Access Compliance Report

Public Rights-of-Way (Curb Ramps)

Intersection ID: 10013834	Main Street: IKEA_BV	Cross Street: N/A	Location: SW
ADA ID: 6367C64DABAB	Ramp Type: PerpDiag	Initial Pass/Fail: Fail	Overall Compliance: No
Severity Score: 8.75			
Codes/Mitigation Info/Possible Solution		Field Measurements/Component Compliance

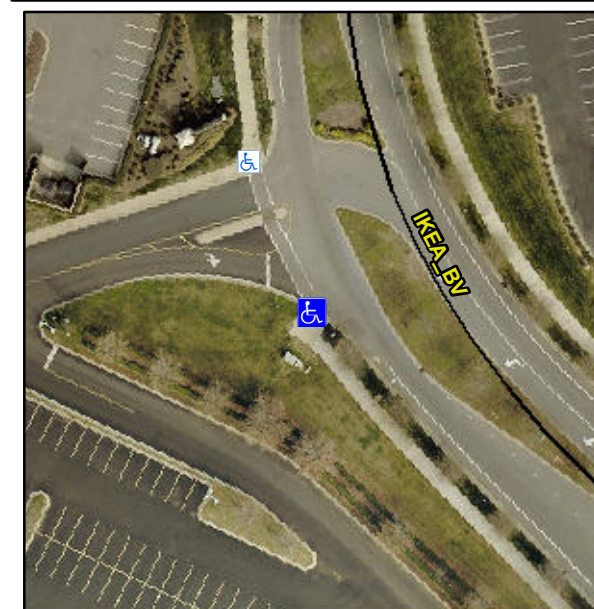
Not Found, R304.5.1

Compliance	Description	Data	Compliance	Description	Data
N/A	Ramp Length (in)	96.0	Yes	Ramp Slope (%)	7.7
No	Ramp Width (in)	43.5	Yes	Ramp XSlope (%)	1.1
N/A	Flare Type LT	N/A	N/A	Flare Type RT	N/A
N/A	Flare Slope LT (%)	N/A	N/A	Flare Slope RT (%)	N/A
N/A	Flare Traversable LT?	N/A	N/A	Flare Traversable RT?	N/A
N/A	Landing Length (in)	N/A	N/A	DWS Provided?	N/A
N/A	Landing Width (in)	N/A	N/A	DWS Contrast?	N/A
N/A	Landing Slope (%)	N/A	N/A	DWS Length (in)	N/A
N/A	Landing X Slope (%)	N/A	N/A	DWS Full Width?	N/A
N/A	Landing Curb? (Y/N)	N/A	N/A	DWS Offset (in)	N/A
N/A	Shared Landing?	N/A			
N/A	Gutter Ponding?	N/A	N/A	Gutter Slope (%)	N/A
N/A	Gutter Lip Ht (in)	N/A	N/A	Gutter X Slope (%)	N/A
N/A	Painted X Walk1?	No	N/A	Painted X Walk2?	Yes
	X Walk 1 Direction	To E		X Walk 2 Direction	To N
N/A	X Walk 1 Width (in)	N/A	N/A	X Walk 2 Width (in)	76.0
	X Walk 1 Slope (%)	1.3		X Walk 2 Slope (%)	4.5
	X Walk 1 X Slope (%)	0.9		X Walk 2 X Slope (%)	1.2

Remove & Replace Curb Ramp With Two New Directional Ramps or Equivalent.
